PROPOSED CHRISTMAS FARM, LAND TO THE SOUTH OF LLAY ROAD, CEFN-Y-BEDD, WREXHAM

PLANNING APPLICATION REFERENCE P/2022/0681

ENCLOSURE 1 – LHA COMMENTS DATED 03/02/23

MEMORANDUM

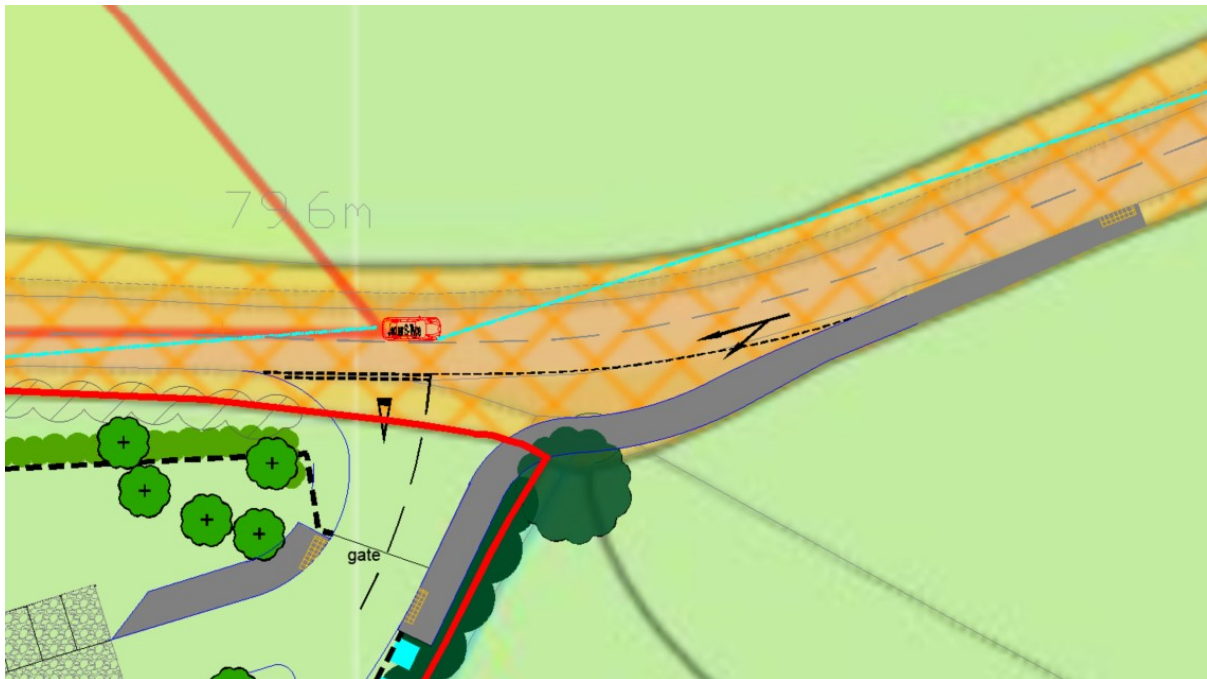
Comment 2: “The forward visibility splay shown on the drawing for 158m from a vehicle approaching the site from the west is achieved, where the splay touches the footway. However, the forward visibility splay shown on the drawing for 147m between a vehicle waiting to turn right into the site and a vehicle approaching the site from the east, is not achieved due to the existing hedgerow located on the northern extents of Llay Road obstructing the splay. The development site access as it is currently proposed cannot be approved, since inadequate visibility splays is a highway safety concern.

To achieve the required SSD visibility, the vegetation located on the northern side of Llay Road, within the extents of the visibility splay, will need to be cleared. It is noted that the hedgerow on the northern extents of Llay Road is not within the applicant’s current ownership.”

The assertion that the requisite 147m forward visibility splay from vehicles approaching from the east towards vehicles turning right into the site is not achievable, without third party land, is technically incorrect.

The extent of the adopted highway boundary has been obtained from the WCBC website (weblink [here](#)) and underlaid onto AXIS drawing number 3034-01-D02B.

A screenshot showing this exercise is provided below. Note that the adopted highway is shown in yellow hatch and the 147m forward visibility splay is shown in cyan:-

As shown above, the forward visibility splay falls wholly within the adopted highway boundary.

**ENCLOSURE 2 – DRAWING NO. 3034-01-D02B: PROPOSED SITE ACCESS
ARRANGEMENTS AND VISIBILITY SPLAYS**

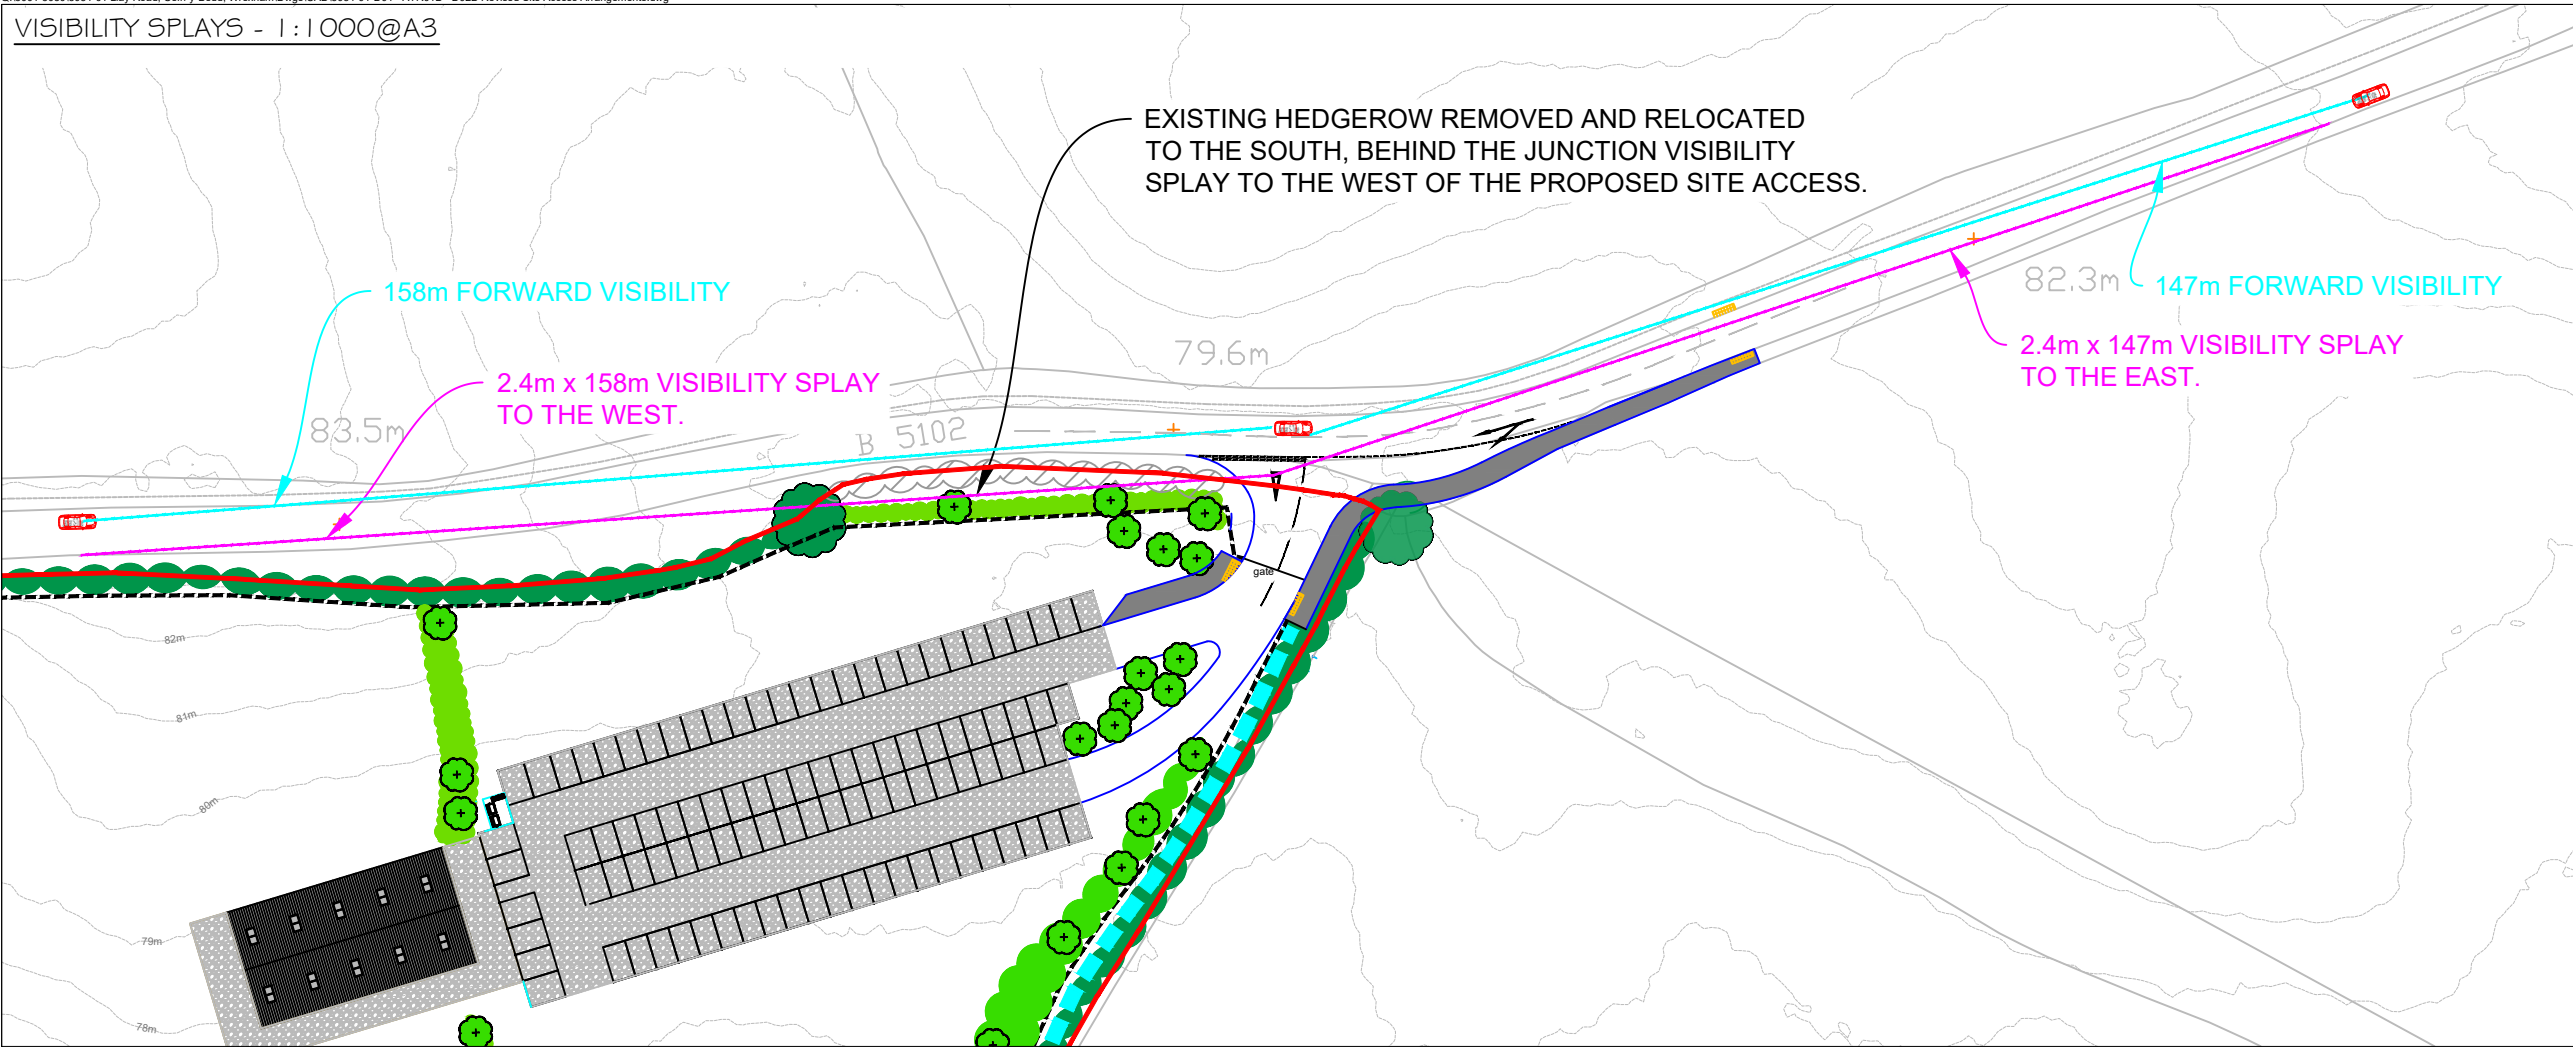
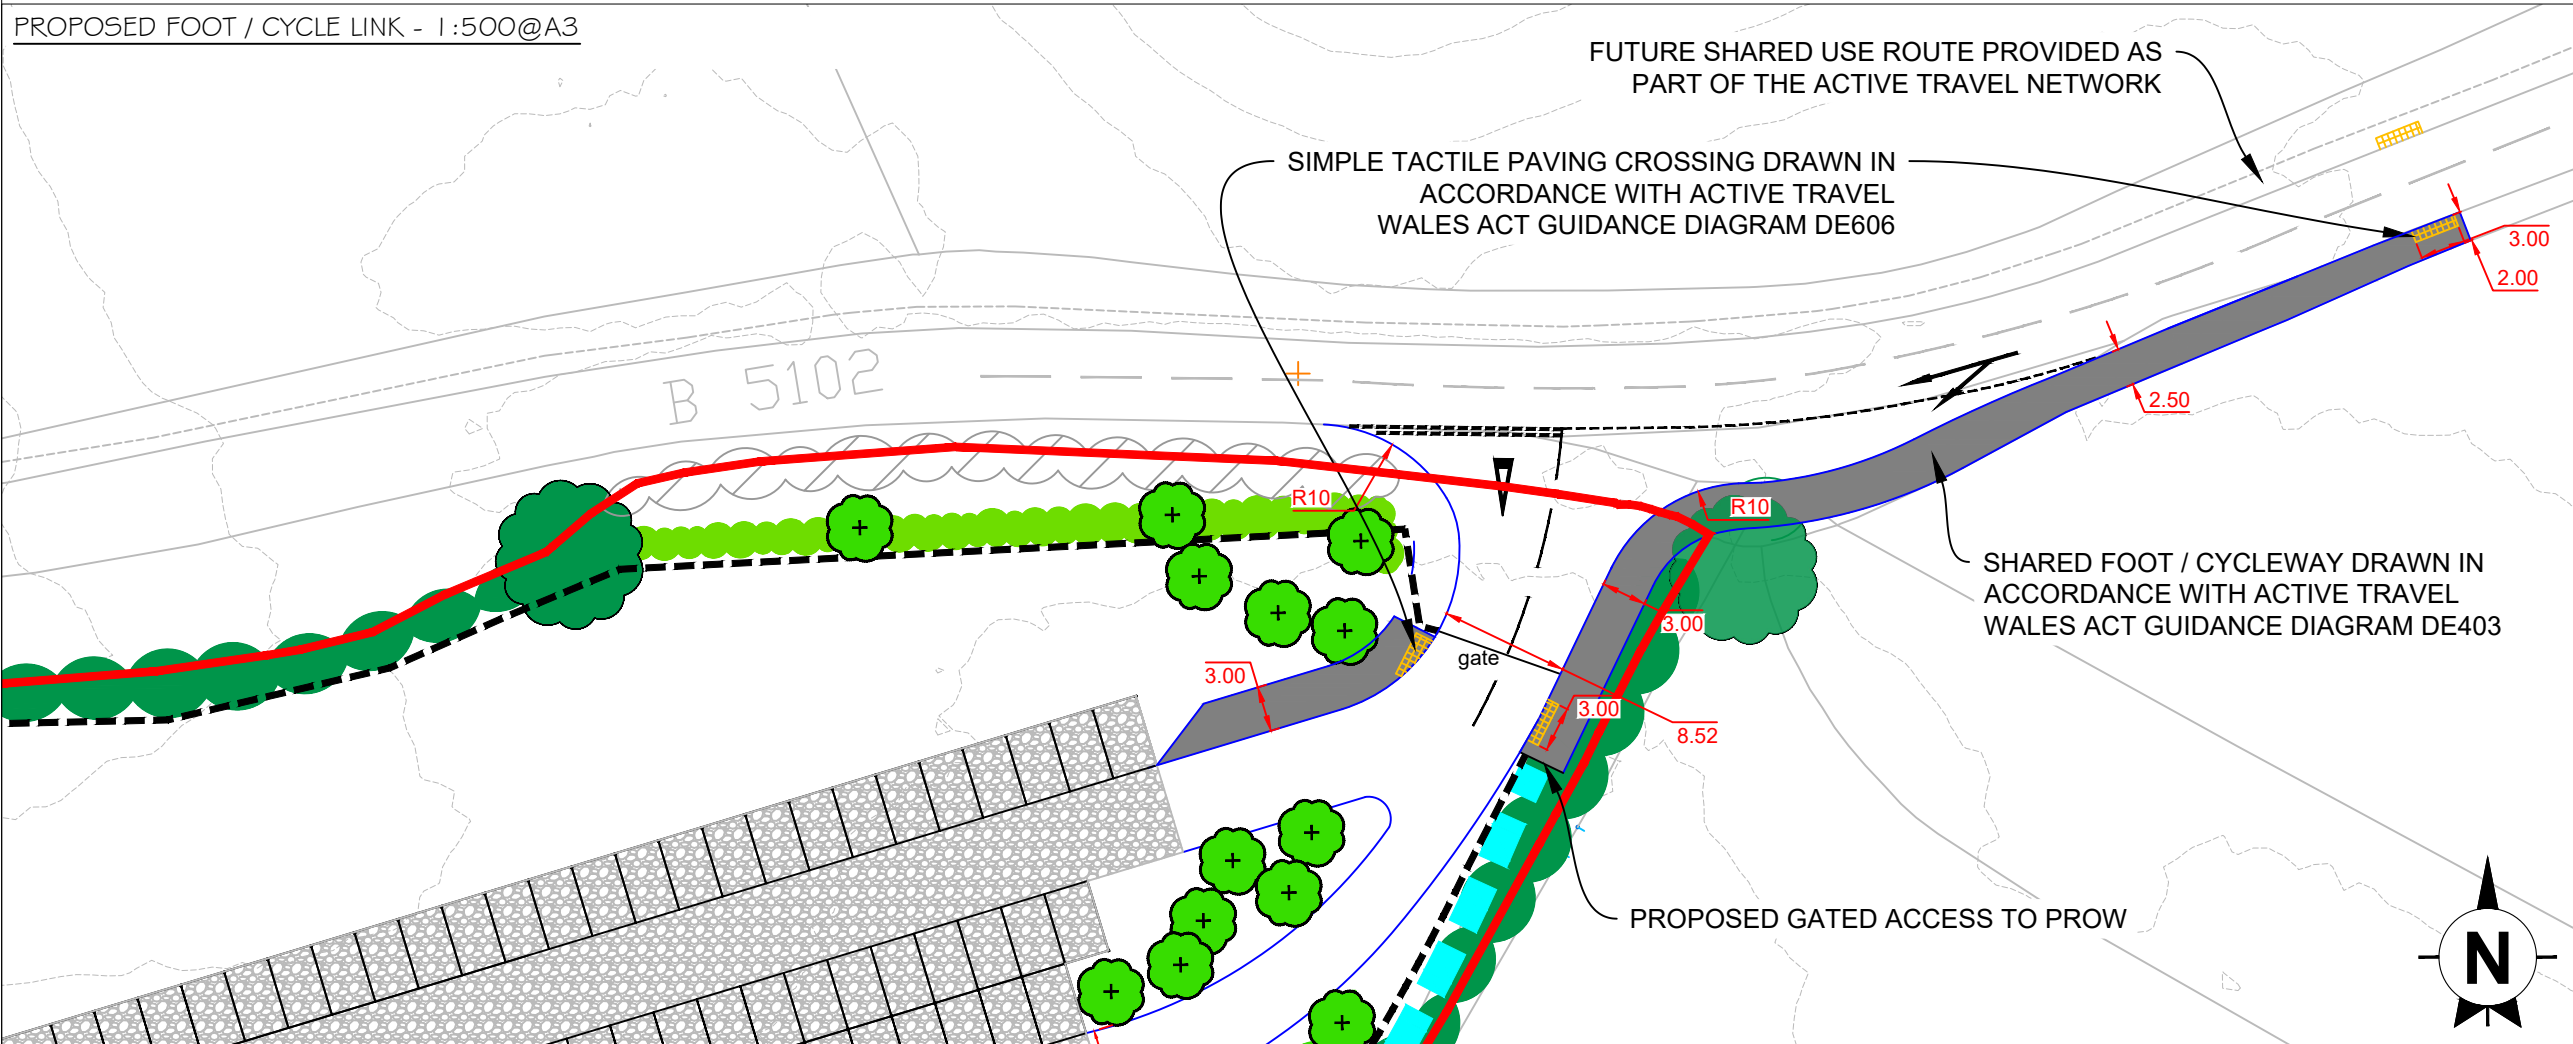
Comment 5: "The revised 'Site Access Arrangement and Visibility Splays' drawing (Drawing No. 3034-01-D02A) illustrates the site access has been amended to include a 3m shared foot / cycleway leading into the site and a tactile paving crossing point integrating the site into the proposed future Active Travel Network infrastructure on the northern side of Llay Road. Although the crossing point is welcomed, there is concern that the visibility on the northern side of Llay Road adjacent to the crossing point is

impeded by the bend in the road. It is suggested the tactile crossing point is relocated further east on Llay Road so as the adjacent crossing point will have better visibility for pedestrians waiting to cross and vehicles will also have better visibility of pedestrians, particularly if speeds are higher than the speed limit. Since there is an existing footway on the northern side of Llay Road, a tactile crossing point should be provided adjacent to the proposed tactile on the southern side of Llay Road to facilitate crossing in the interim."

The revised '*Site Access Arrangement and Visibility Splays*' drawing (Drawing No. 3034-01-D02A) illustrates a forward visibility splay of 158m from a vehicle approaching the site from the west, and a forward visibility splay of 147m between a vehicle waiting to turn right into the site and a vehicle approaching the site from the east, based on the 52.6mph and 50.00mph observed 85th percentile speeds, respectively. The splays are in line with Stopping Sight Distances (SSDs) in Design Manual for Roads and Bridges (DMRB), which is considered appropriate for the type of road being assessed. Both sides of Llay Road are lined by an existing hedgerow that bounds several parcels of land. The forward visibility splay shown on the drawing for 158m from a vehicle approaching the site from the west is achieved, where the splay touches the footway. However, the forward visibility splay shown on the drawing for 147m between a vehicle waiting to turn right into the site and a vehicle approaching the site from the east, is not achieved due to the existing hedgerow located on the northern extents of Llay Road obstructing the splay. The development site access as it is currently proposed cannot be approved, since inadequate visibility splays is a highway safety concern.

To achieve the required SSD visibility, the vegetation located on the northern side of Llay Road, within the extents of the visibility splay, will need to be cleared. It is noted that the hedgerow on the northern extents of Llay Road is not within the applicant's current ownership.

As indicated above, the suggestion to locate the proposed tactile paving crossing point further to the east and to provide tactile paving on both sides of Llay Road is accepted. **Drawing No. 3034-01-D02B** in **enclosure 2** and **Drawing No. 3034-01-ATR01B** in **enclosure 3** show the revised crossing arrangements. The proposed foot / cycleway will be provided to a minimum width of 2.0m, widening to 2.5m and then 3.0m within the site. The proposed crossing point is positioned away from the bend to provide greater pedestrian visibility whilst crossing, as suggested in the most recent comments.

Revision History		Date
A	FOOT / CYCLE ARRANGEMENT REVISED PER COMMENTS BY ACTIVE TRAVEL OFFICER	04.11.22
B	FOOTWAY EXTENDED TO EAST AND TACTILES ADDED	17.2.23
